PARTS & SERVICE NEWS

Ref.no.	AH04007
Date.	05.07.2004

Subject: Modification procedure of muffler bracket on WA470-5H and WA480-5H.

Application: WA470-5H S/N: H50051 up to H50811

1. Introduction

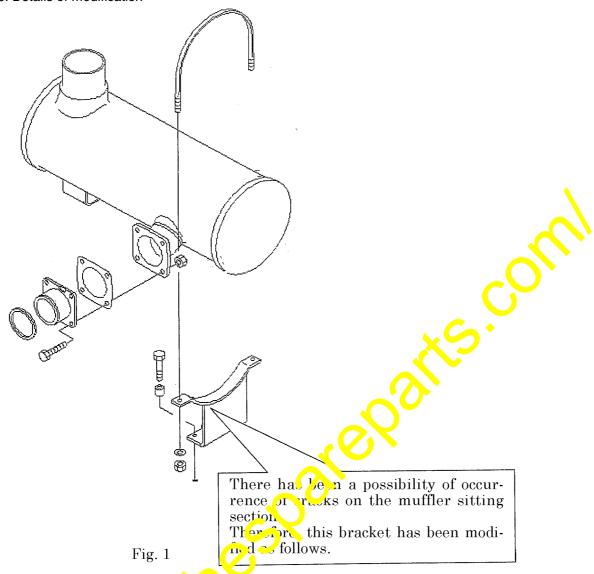
When cracks occur on the muffler bracket for the SAA6D125 engines being used for the WA470-5H and WA480-5H wheel loaders, repair the cracks following the modification procedure described in this Service News.

Details of the modification of the brocket

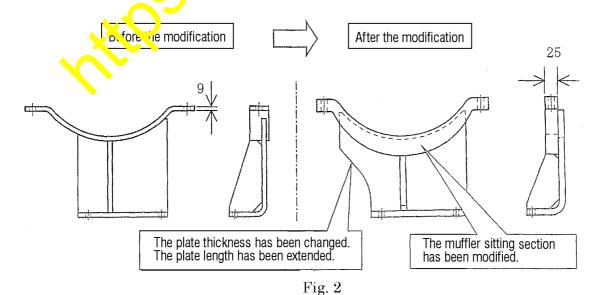
- (1) The muffler sitting section (9 mm thick plate \rightarrow 25 mm machined block)
- (2) The plate thickness has been changed and, moreover, the plate length along the muffler sitting section has been extended.

Fig. 3

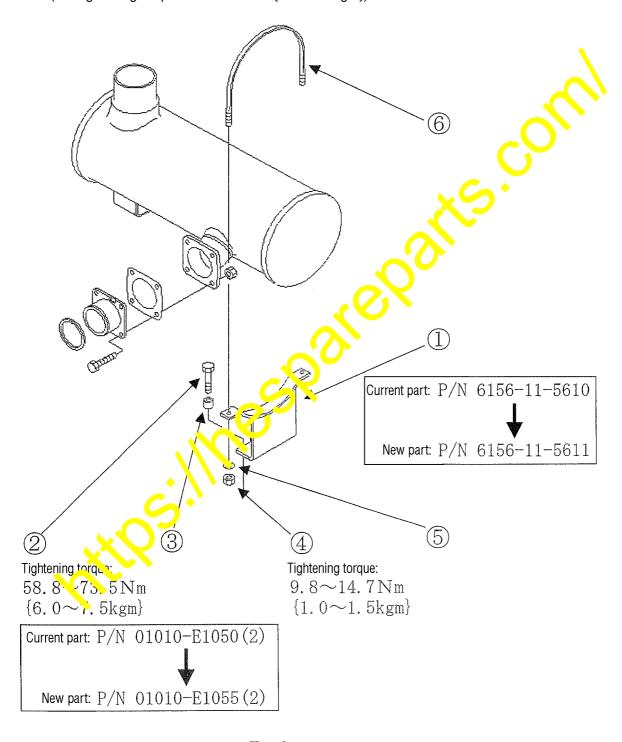
- (1) Loosen the nut @ remove the band @.
- (2) Loosen the bolt ② and remove the bracket ①.

(1) Fasten the new bracket ① by the spacers ③ and the new bolts ②. (Bolt tightening torque: $58.8 - 73.5 \text{ Nm} \{6.0 - 7.5 \text{ kgm}\}$)

(2) Setting the band ©, fasten it by the nuts ④ and washers ⑤. (Nut tightening torque: 9.8 – 14.7 Nm {1.0 – 1.5 kgm})
